GREATER CAMBRIDGE PARTNERSHIP

PAGES
9. Milton Road and Histon Road: Bus, Cycling and Walking Improvements, Delivery Priorities, Local Liaison Process and Design Principles	1 - 36

Appendix B
MILTON ROAD LLF RESOLUTIONS AND OFFICER RESPONSES

MODELLING RESULTS, ‘DO NOTHING’, ‘DO OPTIMUM’, ‘FINAL CONCEPT’

Elizabeth Way Junction

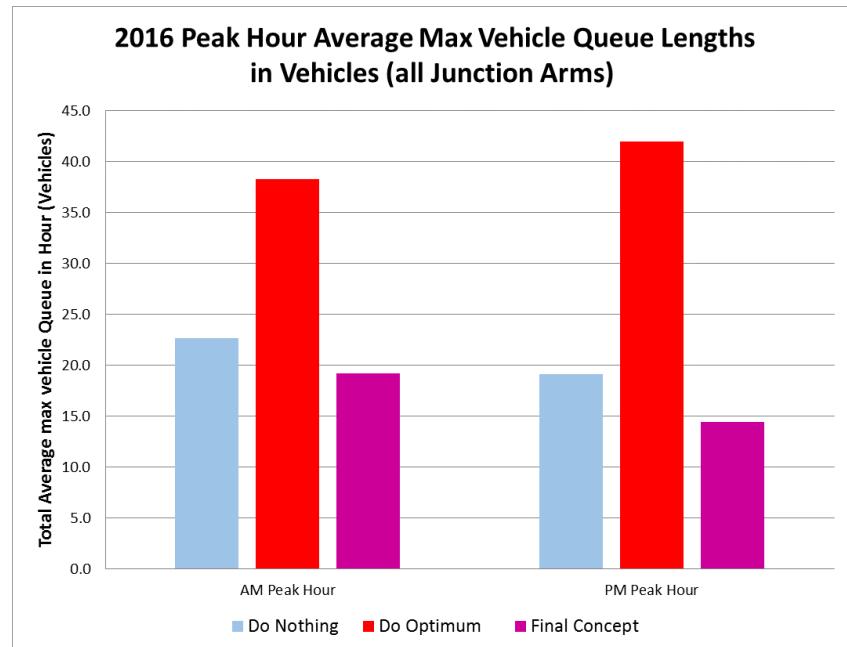
The 'Do Optimum' design promotes the use of a 'Dutch' style roundabout at this junction. While officers agree that this would provide enhanced facilities for pedestrians and cyclists, the modelling of this approach suggests that such a design would severely compromise the vehicular capacity and therefore also have an adverse impact on achieving bus priority.

The modelling shows that the 'Final Concept' proposal to replace the existing roundabout control with a signalised junction design would manage delays much more effectively and provide greater opportunity to prioritise bus movements as well as allowing coordination with the Arbury Road junction through linked signal timings to optimise the progression of buses and to manage and balance main road and side road delays. This could be achieved either through signalising the existing roundabout or through a signalised 'T' junction or crossroads. Both options have strengthens and weaknesses:

- reduce traffic delays compared with a ‘Do Nothing’ scenario
- reduce the high level of injury accidents at the junction involving cyclists
- Require more traffic signal street clutter
- achieve less segregation of cycling movements
- retain access/egress for Highworth Avenue

Whilst the number of daily trips affected by closing off the Highworth Avenue arm is small, local concerns have been raised over the impact on motorised access/egress for Highworth Avenue residents and the ‘Do Optimum’ design addresses these concerns by retaining access/egress directly to/from Milton Road, albeit at a cost to main road movements. Against a backdrop of concern over the accessibility of Highworth Avenue, a signalised roundabout options is suggested within the ‘Final Concept’.

Arbury Road Junction

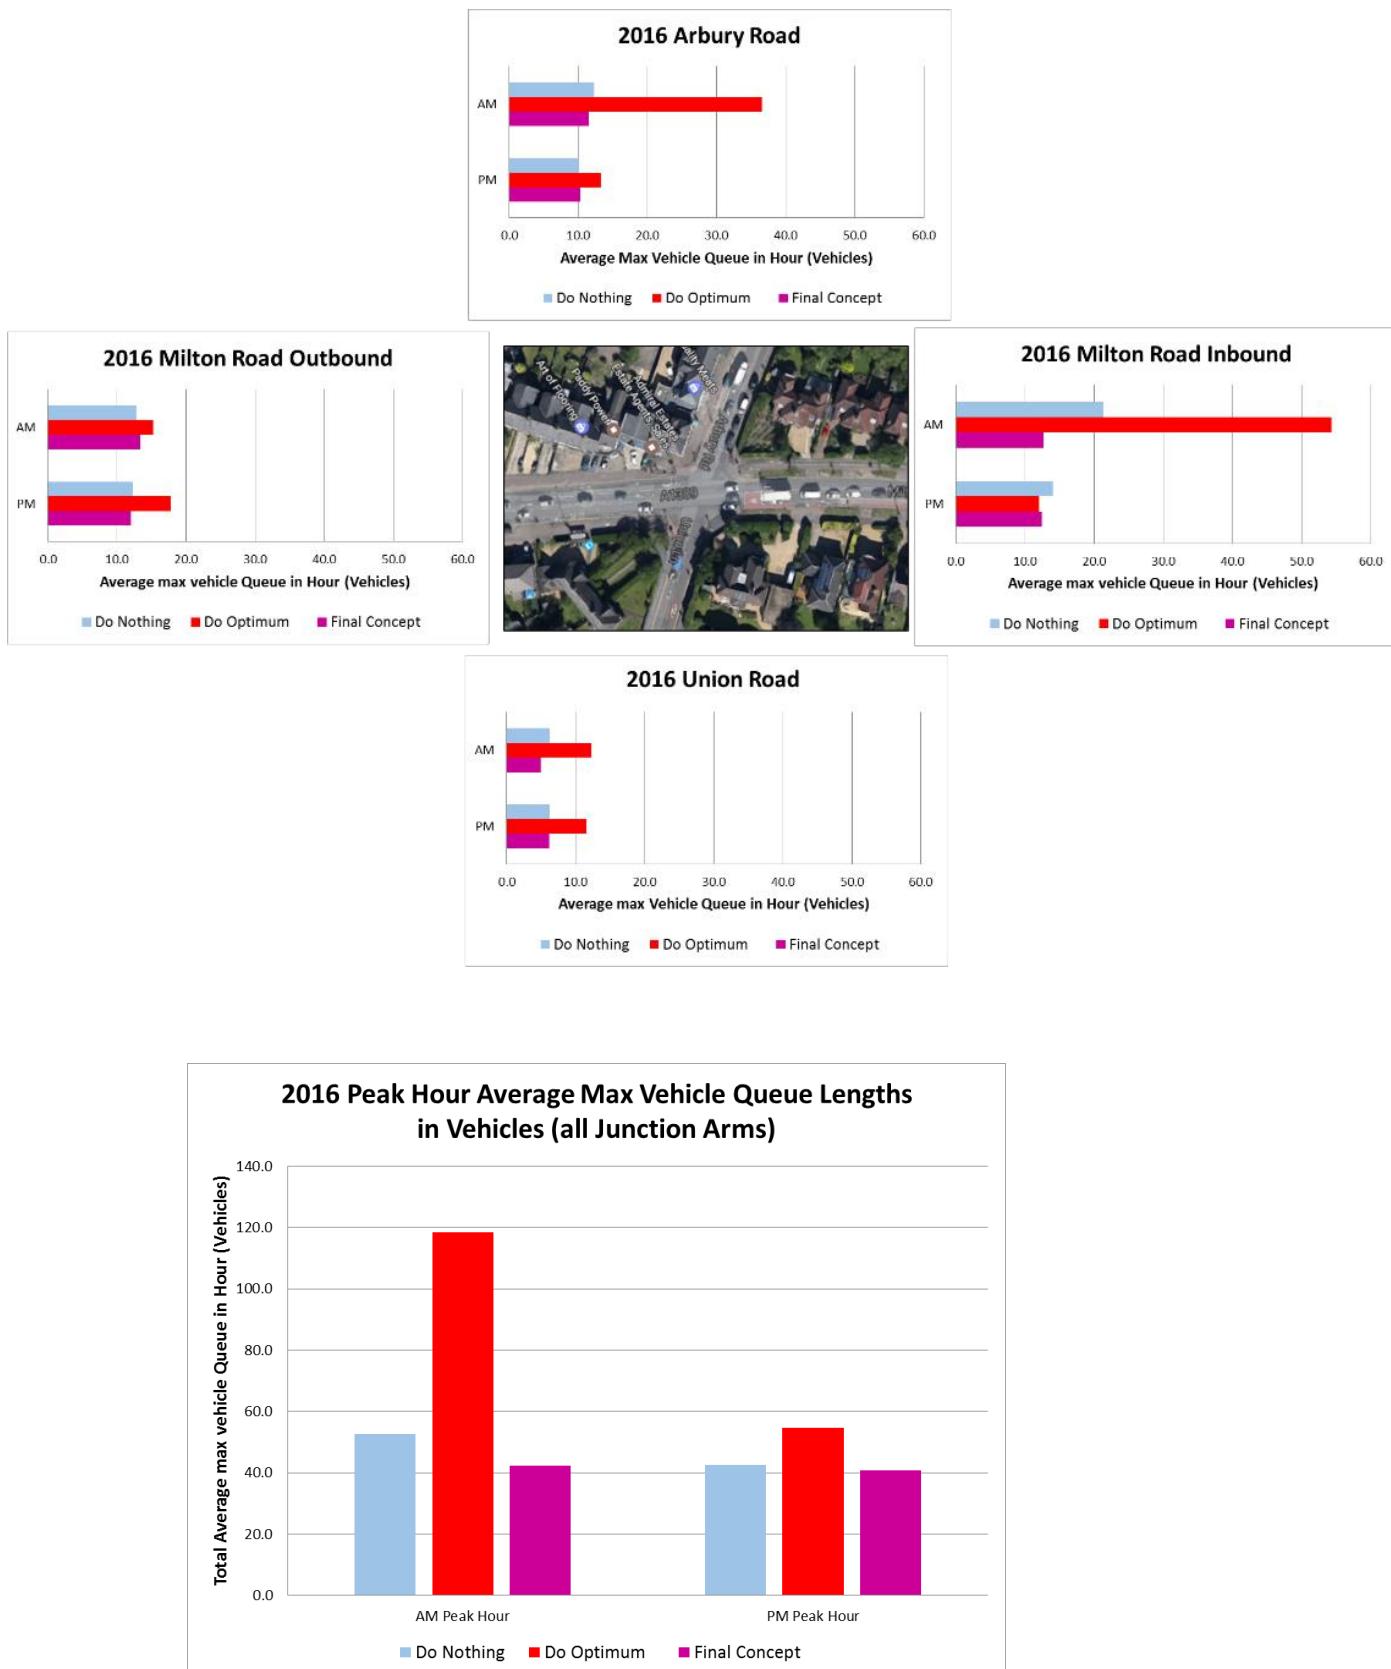
At the Arbury Road / Union Lane junction the 'Do Optimum' design advocates a slight staggering of the layout and a multiple signal stage sequence which would result in much longer delays and queuing. It would also be very difficult to fit this design within the existing highway boundaries whilst maintaining road space for larger vehicles to manoeuvre. The 'Do Something' design proposed closing off the Union Lane arm of the junction to motor vehicle movements. Whilst this approach would be more effective in managing queuing and delays, the concerns over traffic being displaced to other routes within East Chesterton and the impact on local accessibility as a result of closing off Union Lane are recognised and officers have considered alternative design options.

Compromise designs to keep open the Union Lane arm have been explored including the left turn from Union Lane being prohibited. Such an option was shown to reduce queuing on Union Lane itself whilst allowing the Union Lane signal stage to run at the same time as the main road crossing stage thereby optimising the signal sequence to allow a greater proportion of 'green time' to be given to the main road. However, feedback from the LLF suggests any restriction on traffic movements at the junction would be unacceptable to the local community despite the benefits that could accrue in terms of managing overall traffic delays. Therefore, within the 'Final Concept' the existing junction signal operation has been retained with further consideration to be given to the segregation of cycling movements as part of detailed design work.
